# TECHNICAL SERVICE BULLETIN

NO. 2007

All Jeep Vehicles with a Type O Front Prop Shaft

Vibration and/or Shaft Drop Out

FIGURE 1

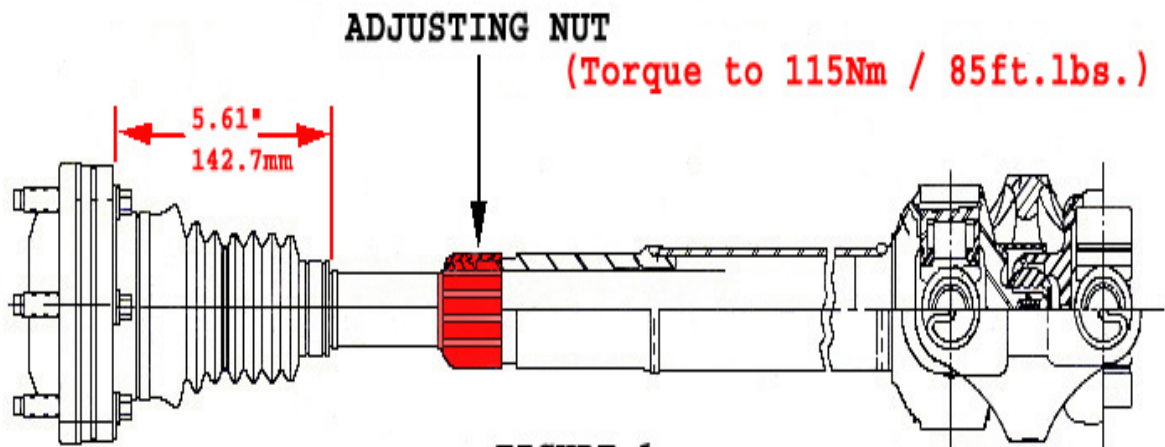
These shafts have an adjustable length and NEED to be ADJUSTED to the individual vehicle's ride height. See figure 1. A shaft that has been in use for a long time cannot be readjusted and must be replaced.

After installation, with the vehicle suspension loaded, turn the wheels left to right lock several times leaving the wheels pointed straight ahead. Now measure the CV joint boot as indicated in figure 1. The shaft end of the boot must be in its groove. Now loosen the adjusting nut and the shafts will slide in or out to achieve the 5.61-inch distance of the boot. Then torque the adjusting nut to 85 foot-pounds.

This MUST be done to any new or R&R'd Prop Shaft installed on Jeep Vehicles. The suspension ride height will not be the same on any two vehicles and needs to be set on each Prop Shaft.
